**KINGSTON FOSSIL PLANT (KIF) - ANNUAL STABILITY INSPECTION OF
WASTE DISPOSAL AREA DIKES**

TENNESSEE VALLEY AUTHORITY
KINGSTON FOSSIL PLANT
ANNUAL ASH POND DIKE
STABILITY INSPECTION

Prepared by: Sherman G. Garrett
Date: December 13, 2004

**KINGSTON FOSSIL PLANT
ANNUAL ASH POND DIKE STABILITY INSPECTION
2005**

Photo 1—Looking north toward collector sump and pump for dredge cell seepage

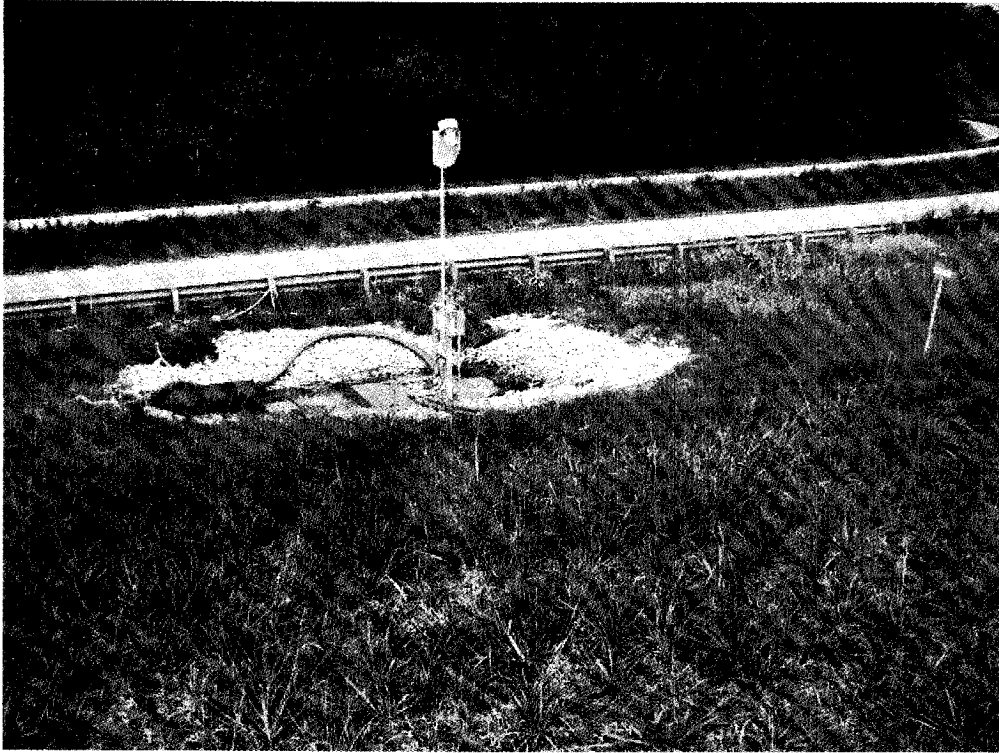
After November 2003, dredging operations to this area ceased due to a leak in the toe of the dike slope for dredge cells 2 & 3. The leak has not been stopped, but corrective action to prevent runoff into the river was undertaken by providing slope stabilization and adding a collector sump and pump to redirect the runoff (photo 1) into a bench drainage ditch running between dredge cell 2 and the road along Dike C.

Photo 3—Looking southwest at stilling pool spillway discharge diffuser piping

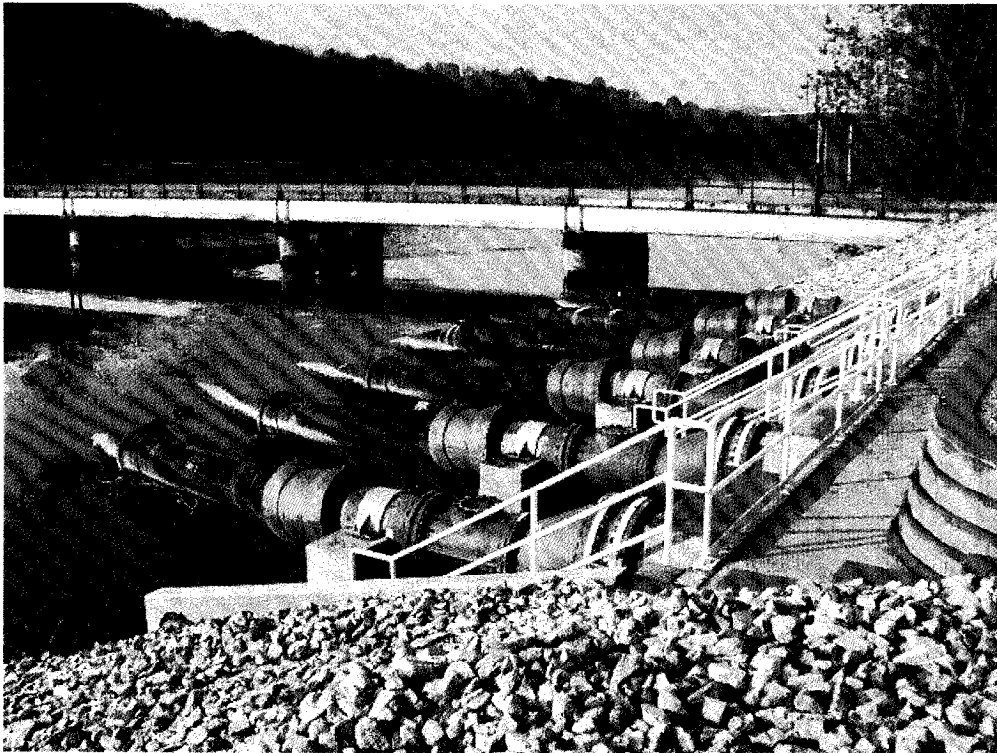
The sluice water flows into the stilling pool through one of two plant constructed spillways. From the stilling pool the water discharges into the plant intake channel via six standard spillways (photo 2). At the time of the inspection, five of the six spillways were operating. The western spillway was raised above the level of the other five and was not discharging. In 2003, new discharge diffusers were constructed (photo 3). Cenospheres were present in both the stilling pool and the active ash pond.

Photo 12—Looking southwest at pump platform and coal yard drainage basin

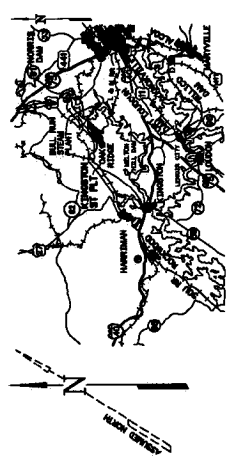
The interior slopes appeared to be in satisfactory condition (photos 12 & 13). Normal discharge from this basin is pumped into the fly ash discharge ditch which flows to the active ash disposal area. At the time of inspection, water in the pond was at a low level, about 6" below the first pump start switch—approximate elev. 751.0. The basin was sounded at several places along the perimeter of the platform, and the water was found to have an average depth of 15 inches with the top of sediment being approximate elev. 749.75. The grade elevation in the area of the pump platform is 745.0. This indicates the sediment in the area of the pump platform occupies approximately 4.75 feet of the basin's 6-foot storage capacity. With allowance of a 2-foot clearance below the pump intakes to prevent the pumps from pumping solids, the maximum sediment elevation should be no greater than 749.5. This indicates that the pumps are probably pumping solids. The basin should be dredged annually to maintain optimum pumping performance. The pond extensions for overflow appeared to have built up with sediment limiting the storage capacity of the pond (photo 14). Kingston drawing 10W225-1 shows the pond and its intended bottom contours.

- Dredge the Coal Yard Drainage Basin to restore its design contours and protect the pumps from damage by removing approximately 3,300 cy of sediment from the original section and the south and east "wye" extensions. See Kingston drawing 10W225-1.
